NL-04-1367

**Joseph M. Farley Nuclear Plant Units 1 and 2
Response to Third Request for Additional Information Related to
Request to Revise Technical Specifications - Containment Equipment Hatch**

SNC Response to NRC Request for Additional Information

Figure 1

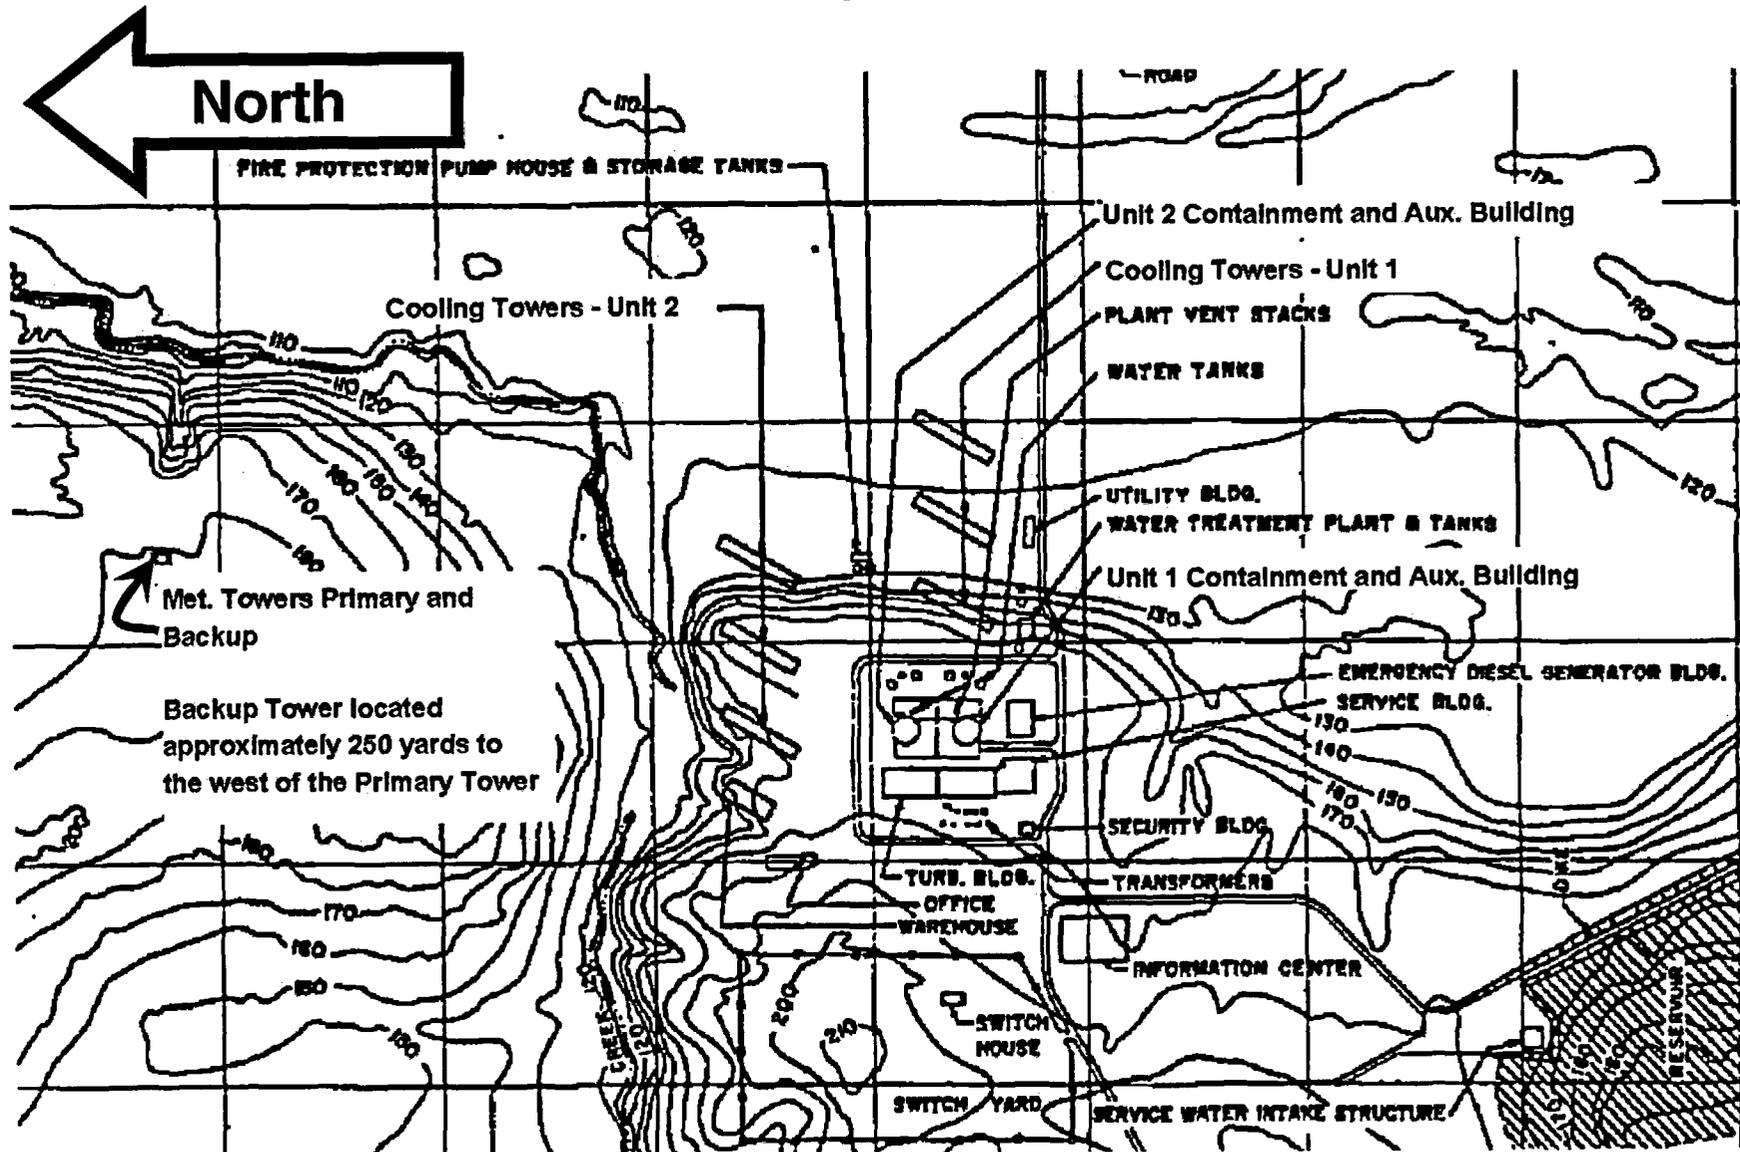
- a) Please provide a site plan for the Farley Nuclear Plant showing the locations of the reactor building complex, cooling towers, and primary and backup meteorological towers. Please also provide a description of the primary and backup meteorological tower structures (e.g., structure type and dimensions, instrumentation boom length and direction, etc).

Figure 1 contains an excerpt of FNP FSAR Figure 2.3-27, "Plan Showing Site Topography and Plant Structures." The containment buildings, cooling towers, and meteorological towers, are identified on this drawing. Pictures and descriptions of the primary and backup meteorological tower structures (e.g., structure type and dimensions, instrumentation boom length and direction) are provided in Figure 2.
